DOCUMENT NUMBER: 17-00166
ISSUE NUMBER: 1
ISSUE DATE: May, 96

VCO 2 Unlock in 9323 and 9360 series transceivers

Figure 1: Position of R73 and R74 (Bottom Left Hand Corner of 08-04962)

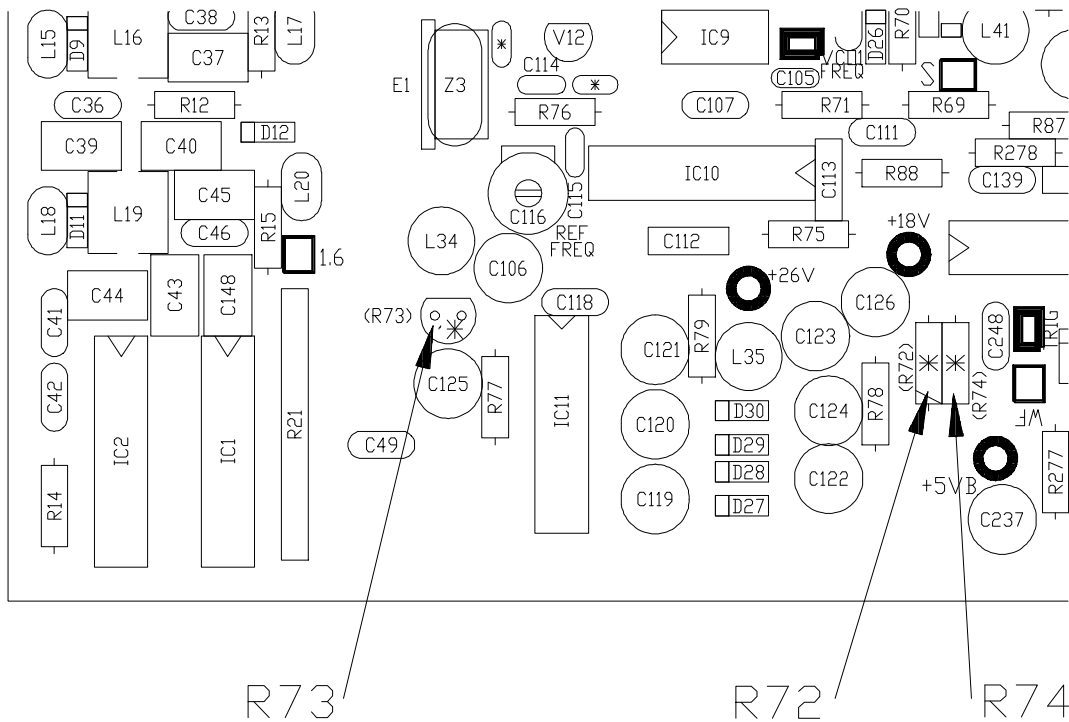
The overlay diagram 08-04962-001 shows the position of R72 and R74 transposed. The correct position of R74 is adjacent to C248 and test point +5VB.

1. Disconnect power from the transceiver and remove from the installation.
2. Remove the top cover.
3. Referring to the diagram, locate the position of R73 and R74. (Neither of these resistors are fitted).

4. Remove the Receiver Exciter assembly from the chassis.
5. Using tinned Copper Wire (TCW), fit and solder a link into the holes marked R73. Trim excess lead length.
6. Fit and solder the 1K Ω resistor into the holes marked R74. Trim excess lead length.
7. Fit and secure the Receiver Exciter assembly into chassis.
8. Refit plugs ensuring correct placement and orientation.
9. Fit top cover
10. Reinstall
11. Connect power.
